Subject: **Bid #: 8501-W6, Complete Streets Improvements – Endicott – Bigelow / DPW - CDBG**

**ADDENDUM NO. 5**

#### **Green Island Phase II Addendum No. 4: Questions and Clarifications**

Number: **L504**

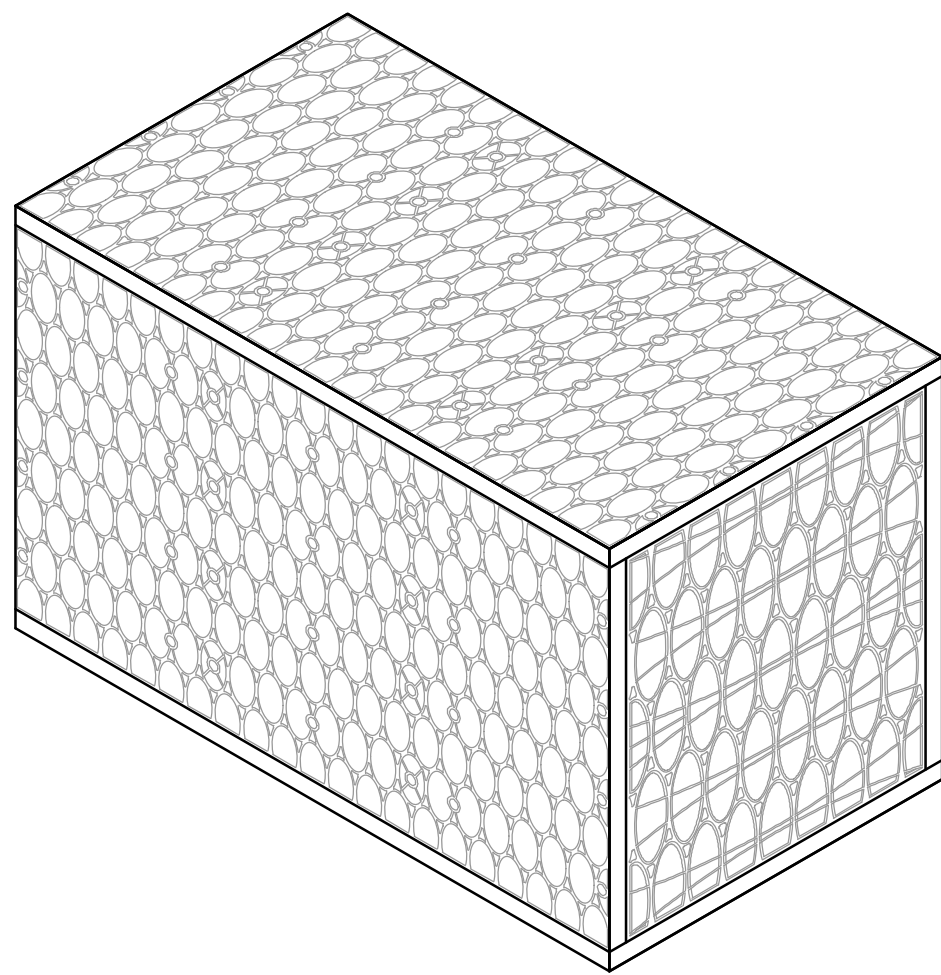
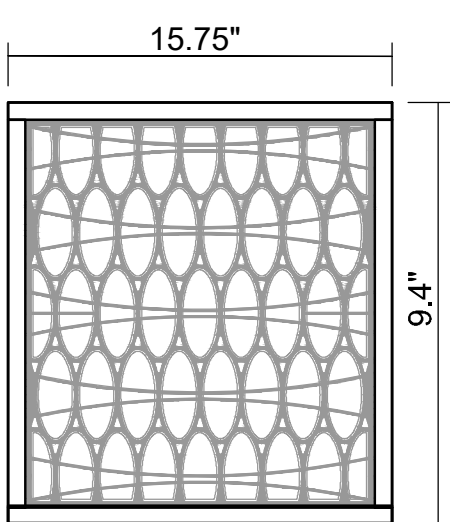
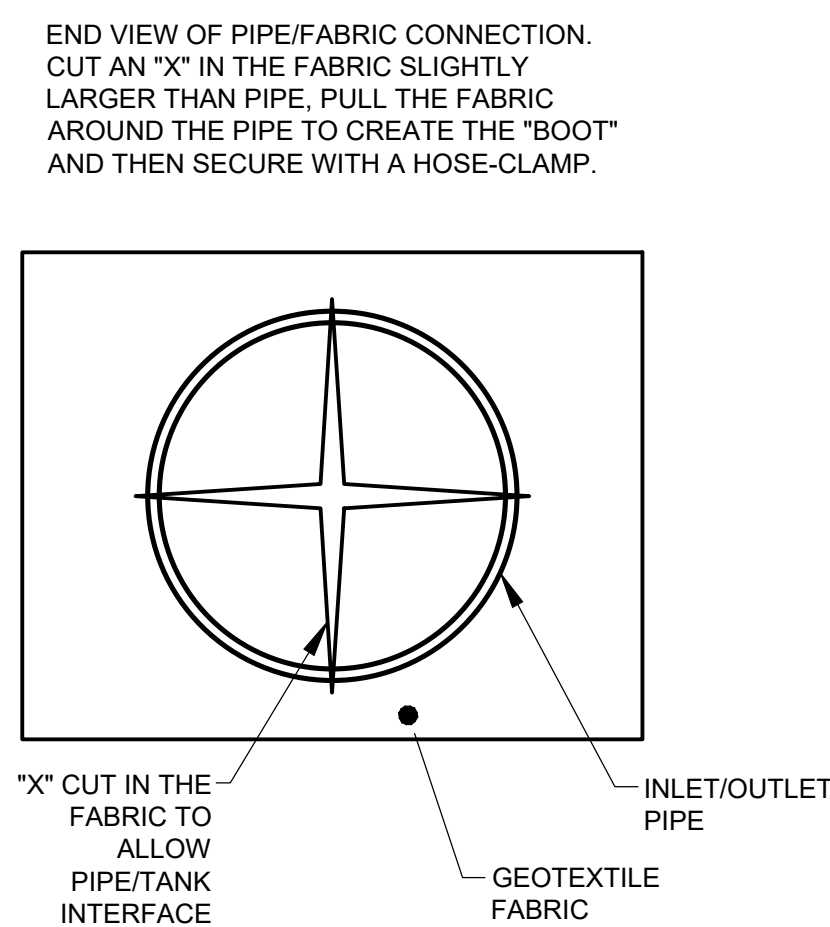
**Q: The "Hot Mix Asphalt Pavement, Mill And Overlay" detail (Detail 4) on plan sheet L504 calls for 1 ½" Mill and Overlay. We assume that bid item #58 (Mill & Overlay Bituminous Concrete @ 1.5") is the proper item to pay for this work. What is bid item #21 (Remove & Dispose Asphalt Pavement – Mill @ 2") for?**

**Q: Please verify that bid item #22 (Remove & Dispose Asphalt Pavement – Full Depth) is only for the removal and disposal of asphalt in the full depth sections. If so, under what bid item will the contractor be paid for the full depth excavation to install all of compacted dense graded crushed stone shown on Detail 2 and 3 on plan sheet L504?**

**Q: Under what bid item is the contractor to be paid for the installation of dense grade crushed stone for Hot Mix Asphalt Pavement (Detail #2 & #3 on plan sheet L504), Concrete Unit Pavers (Detail #5 on plan sheet L504), Cast-In Place Concrete Pavement (Detail #9 on plan sheet L-504) and Reinforced Cast-In-Place Concrete Pavement (Detail #10 on plan sheet L504)?**

**Q: Item #57 Impervious Paver Concrete Base (CY) – Detail 5/L504 shows a HMA base**

*A: Removal and disposal of asphalt pavement shall be compensated under bid item #403.1 Grinding Full Depth-6" Maximum for full depth bituminous pavement and #403.0 Grinding and Milling 1 ½" for top course.*

*A: Except in areas where excavation is required for proposed utility work, contractor to remove and dispose pavement only, not base course. For areas where existing bituminous pavement is being removed due to required excavation, contractors shall be compensated under bid item # 127, Dense Graded Crushed Stone.*

*A: Installation of dense graded crushed stone shall be compensated under bid item# 127, Dense Graded Crushed Stone.*

*A: Pavers on bituminous concrete base shall be compensated under bid item # 447, Modular Unit Paver Sidewalk.*
